January 26, 2023

**Contract 2023-10
2023 Paving of Various County and Township Roads**

Addendum #1

Milford Township

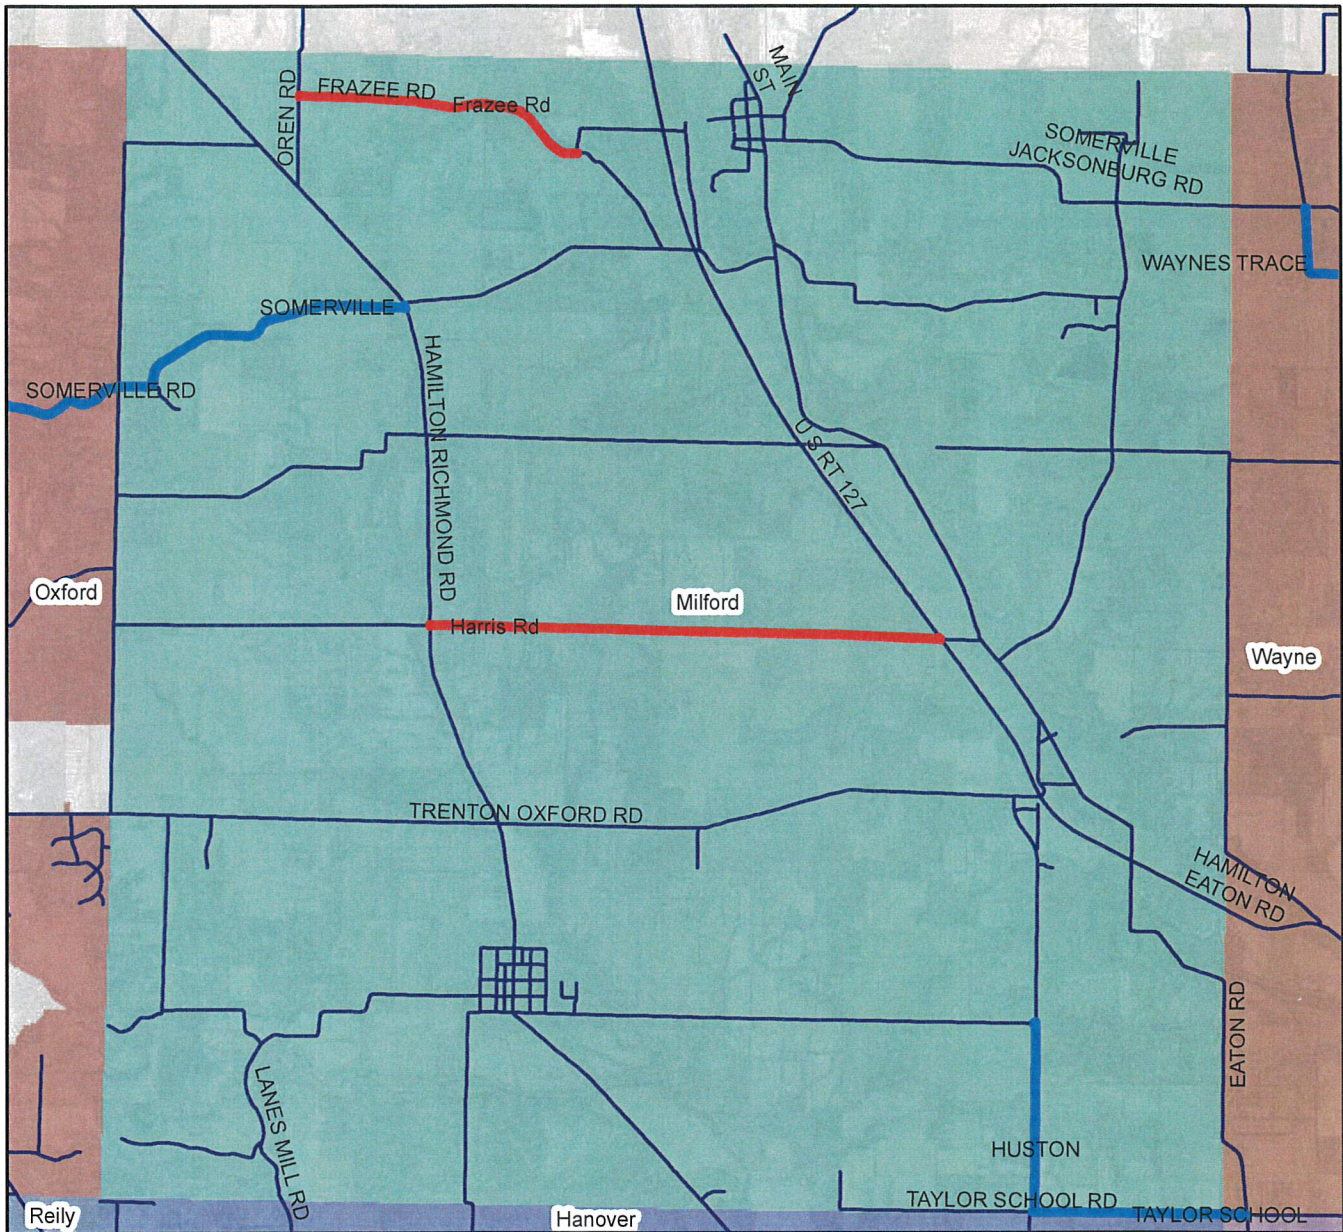
Add Sheet: Updated Milford Twp Map.
